[Docket No. FAA-2020-0883; Project Identifier 2019-CE-034-AD; Amendment 39-21460; AD 2021-05-17]

Airworthiness Directives; Rockwell Collins, Inc. Flight Display System Application

ACTION: Final rule.

Figure 1 to paragraph (g)(1)(iii); placard location on bezel

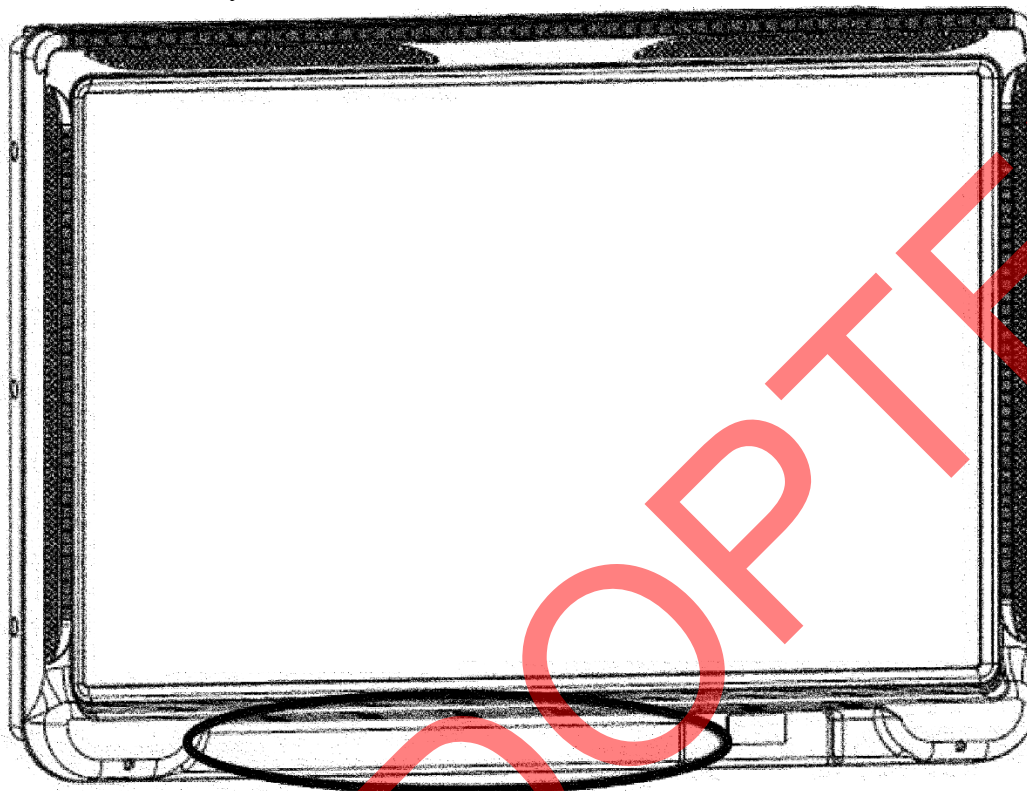
- (1) Within 30 days after July 23, 2019 (the effective date of AD 2019-12-09), do the following:
 - (i) Revise the airplane flight manual (AFM) or AFM supplement (AFMS) by adding the following text to the Limitations section: For TCAS II installations, during flight, do not operate TCAS in the “TA/RA” mode; TCAS may only be operated in “TA Only” mode.
 - (ii) Fabricate a placard for each aircraft primary flight display, using at least 1/8 inch letters, with the following text: TCAS Flight Ops–TA Only mode (TA/RA mode prohibited).

(iii) Install the placard on the bottom of each aircraft primary flight display bezel in the area depicted in figure 1 to paragraph (g)(1)(iii) of this AD.

(4) The airplane flight manual revision and placards required by paragraph (g)(1) of this AD may be removed after completing the software upgrade required by paragraph (g)(3) of this AD.
